CITY OF KINGSTON
Heritage Area & Historic Landmarks Preservation Commissions
planning@kingston-ny.gov

Re: RECOMMENDATION of Historic Landmarks Preservation Commission
City of Kingston Proposed Form Based Code

City of Kingston Historic Landmarks Preservation Commission

Recommended Comments on the Proposed Form Based Code

SUGGESTED
REPLACEMENT FIGURE

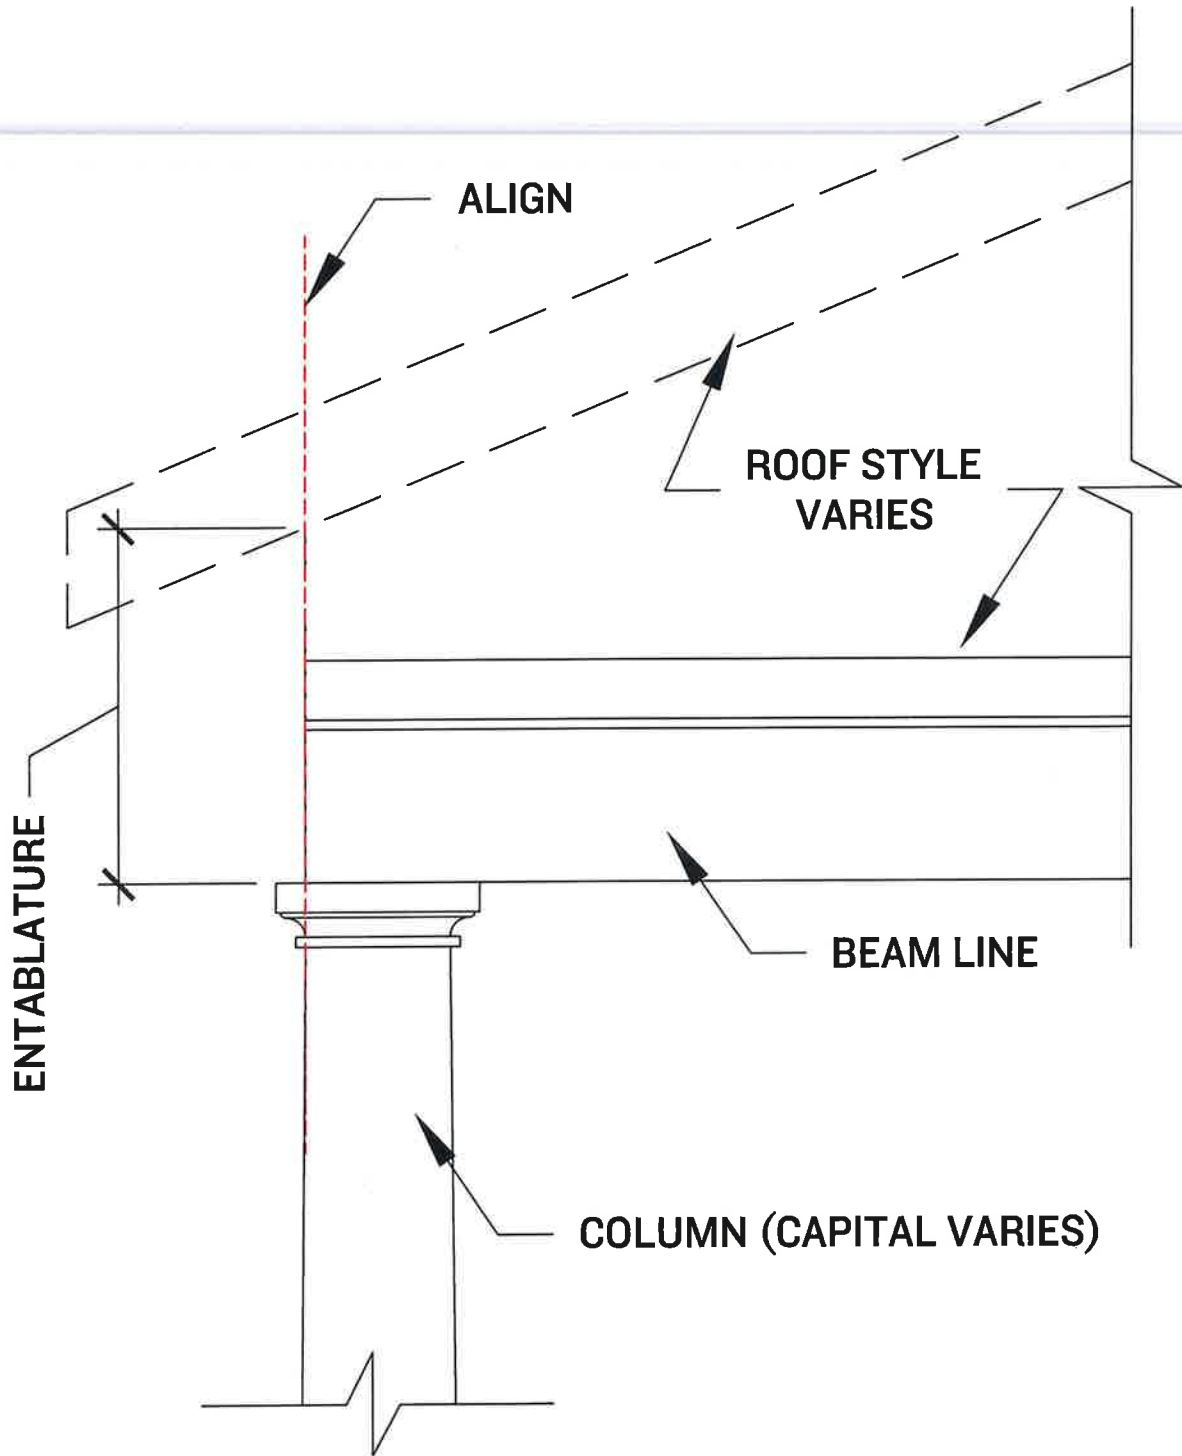
- (d) The HLPC members note that the alignment as shown in Figure 405.G.4.d, has the potential for the column capital to hold water, snow, ice, and debris, ultimately causing rot possibility. The HLPC questions if the figure is a “Blow-up” of Figure 405.14.G.4.c (above it), then without the roof detail, gives rise to more questions/interpretations. *HLPC Provides Alternative Figure for consideration, which would require some minor notes for clarification.*

PIKE PLAN CANOPIES
(WALL STREET AND NORTH FRONT STREET)
UPTOWN URBAN RENEWAL PROJECT NYR-121

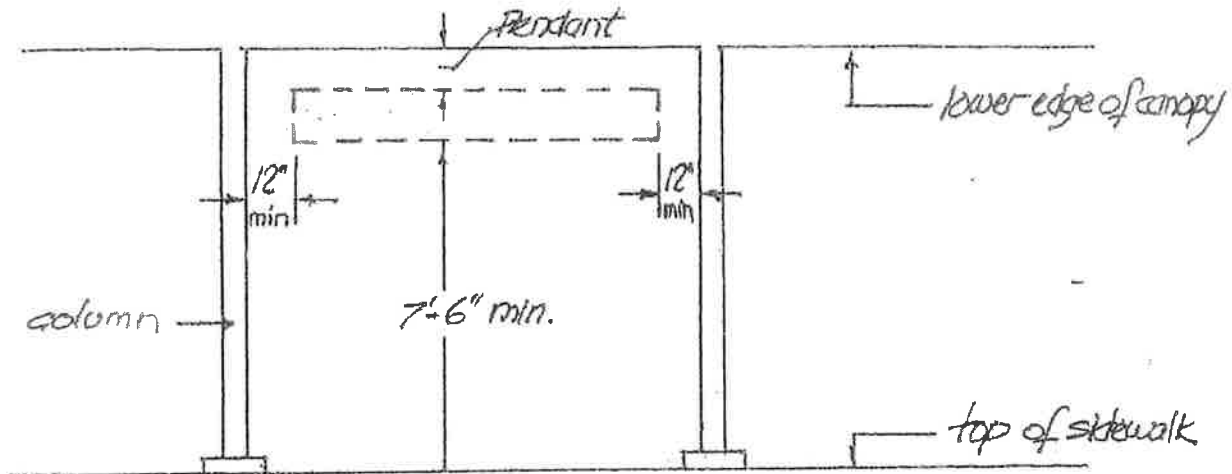
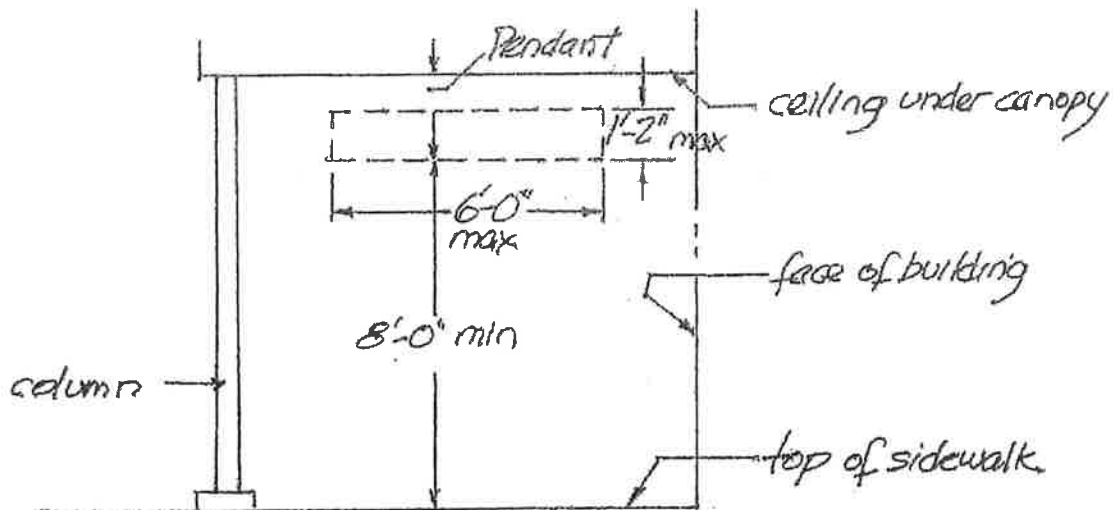
- ADD Signage Regulations that govern the installation of signs both under and along the “Pike Plan” structure on North Front and Wall Streets in the Stockade District. Regulations attached.

GUIDELINES FOR THE INSTALLATION OF SIGNS ON OR UNDER THE PIKE PLAN CANOPIES

1. These guidelines shall apply only to businesses which occupy the ground or street levels of the buildings in the area. All business or office occupying the upper levels of any building in the area may be identified and located solely by a sign or plaque beside the door which permits access to such an establishment.

2. Each business shall be entitled to two (2) signs to identify and locate its establishment, i.e. one (1) on the front of the canopy parallel to the street, and one (1) under the canopy perpendicular to the street.

3. Flashing, moving or intermittently illuminated signs or advertising signs are prohibited.
4. No internally lighted or neon signs are permitted.
5. All signs shall be constructed of wood, with painted or applied lettering, or lettering may be routed. No metal or plastic signs permitted.

6. Lettering must conform to style of middle 1800's or early 1900's.
7. Minimum and maximum distances and dimensions are graphically displayed on the following page.
